Stormwater On-site Water Quality Treatment Memo

Project: Croatia Avenue, Edmondson Park

Project No: 47429

Specifically, this memo addresses item 9b of the Development Application RFI document, which is the interim water quality treatment facilities proposed for the buildings C, D, G and H of the development only until bioretention basins D13 and D14 are constructed and operational.

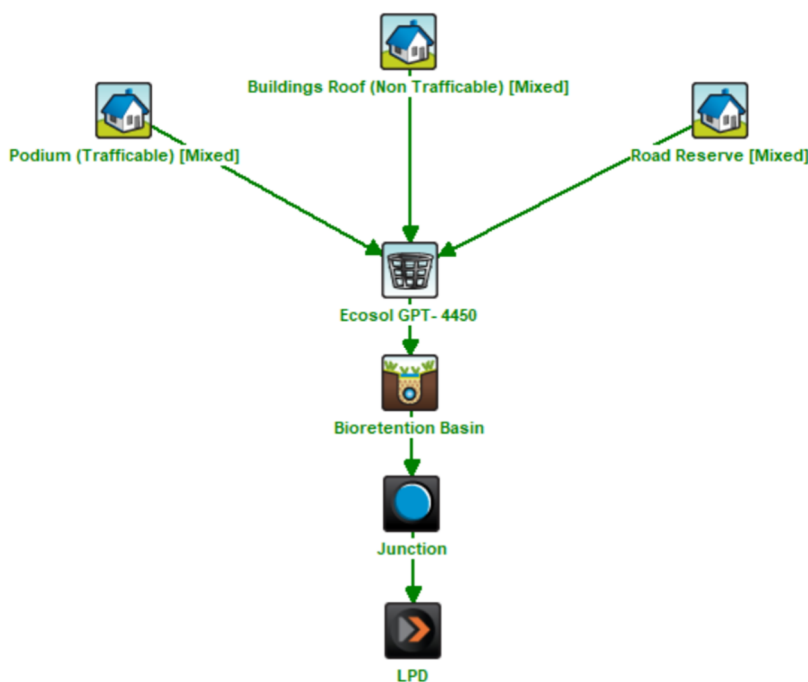
Modelling of the pollutant load for the Croatia Avenue development has been carried out using MUSIC to confirm the proposed treatment measures satisfy the average pollutant load reduction requirements for the site. The stormwater treatment train schematic for each catchment is shown below.

Output data from music software					
	Sources	Residual load	Reduction (%)	Target (%)	Target achieved
Flow (ml/yr)	15.5	14.9	3.7	-	-
Total suspended solids (kg/yr)	3040	201	93.4	85.0	Yes
Total phosphorus (kg/yr)	6.36	2.22	65.1	65.0	Yes
Total nitrogen (kg/yr)	44.6	17.6	60.6	45.0	Yes
Gross pollutants (kg/yr)	378	0	100	90.0	Yes
